## Staff Briefing Papers

Meeting Date January 20, 2022 Agenda Item 4\*\*

Docket No. **E999/CI-16-521**

**In the Matter of Updating the Generic Standards for the Interconnection and Operation of Distributed Generation Facilities Established under Minn. Stat. §216B.1611**

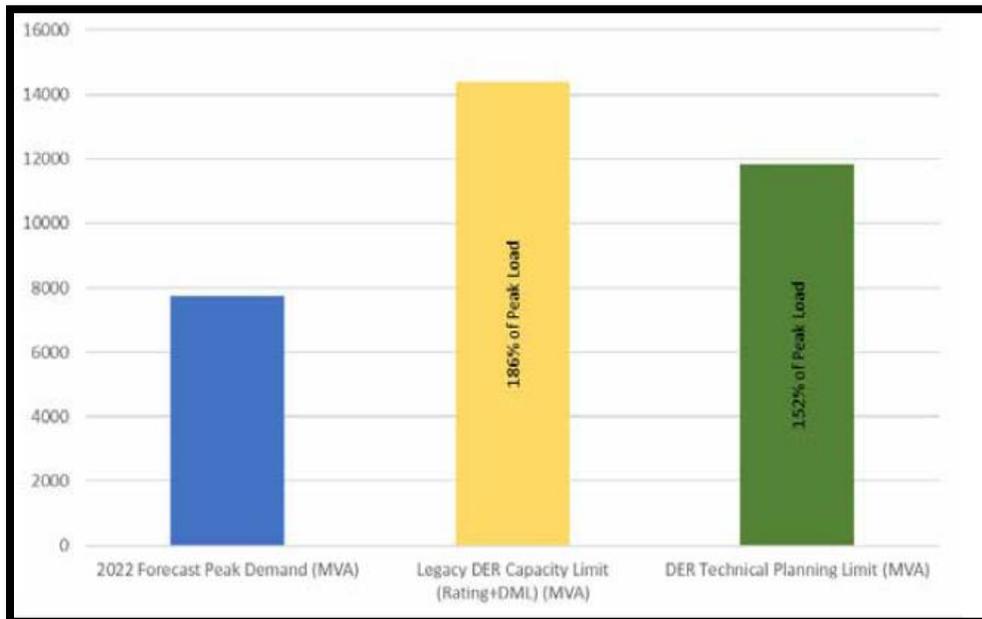
IREC, Fresh Energy, MnSEIA, AES, and SUN all express that the TPL would significantly reduce the total available DER capacity on the system.<sup>75</sup> Fresh Energy asserts that the TPL does not serve the MN DIP’s goal to “give maximum possible encouragement of distributed energy resources consistent with protection of the ratepayers and the public.”<sup>76</sup> Before Xcel revised their TPL to be 80% equipment rating plus DML, they had proposed 100% equipment rating minus the DML. Through an Information Request, Fresh Energy calculated that the total loss of capacity would be 13%. Responding to their new TPL specifications, MnSEIA states that subtracting a flat 20% of equipment instead of subtracting DML would be significantly more limiting.<sup>77</sup> IREC calculated that it would result in a reduction of total available capacity by 2-3 GW which they say was corroborated in Xcel’s September 24, 2021 Office Hours where they

referenced a 2.6 GW reduction.<sup>78</sup> Additionally, IREC offered the following chart to correct a “misleading” Xcel graphic used to represent the TPL that ignored the previous capacity of 100% equipment rating plus DML.

In response, Xcel disagreed with Fresh Energy’s claim that the TPL is counter to the MN DIP’s goals and state that when reviewing the impact of the TPL, it is necessary to look at the overall picture, not just the reduced megawatts.<sup>79</sup> Xcel acknowledged that there will be a net reduction in capacity without equipment upgrades but posits that the “real measure” should be how much load/demand can be served by DER. When the TPL is compared to demand, there remains more than enough DER capacity to serve load. Xcel points out that the potential interconnection of DER would cover around 152% of the forecasted peak demand.

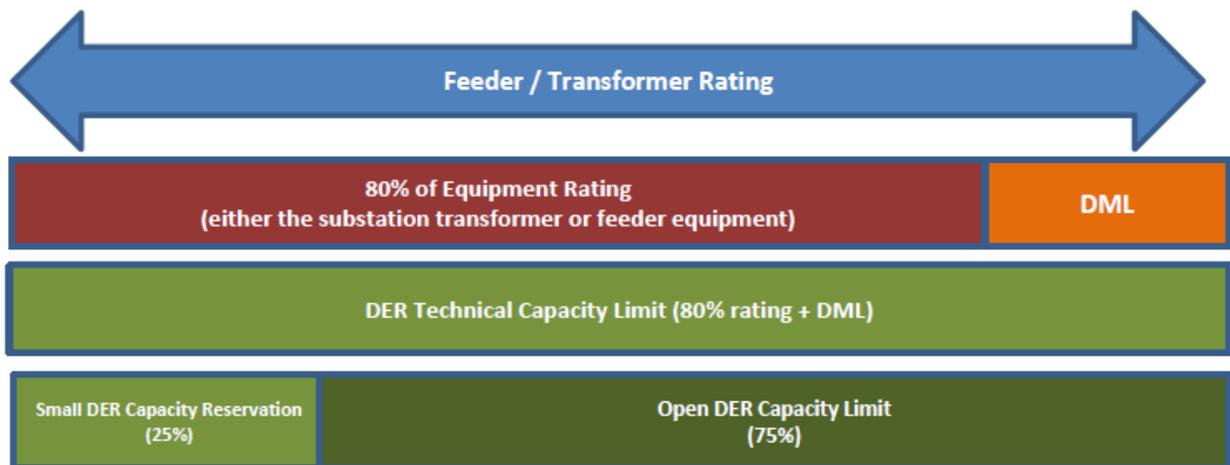
IREC goes on to claim that Xcel creating a planning limit “reveals underlying inadequacies in Xcel’s technical capabilities when it comes to reviewing interconnection applications.”<sup>97</sup> IREC posits that Xcel’s position that the TPL will make the interconnection more streamlined and predictable is just another way of saying the process will be easier because the TPL will “ensure that fewer projects have an opportunity to interconnect.” IREC believes that the MN DIP, modeled after the FERC equivalent, had drafted timelines for projects much larger and more complex than the ones Xcel is seeing and it is Xcel’s lack of staffing capabilities and expertise
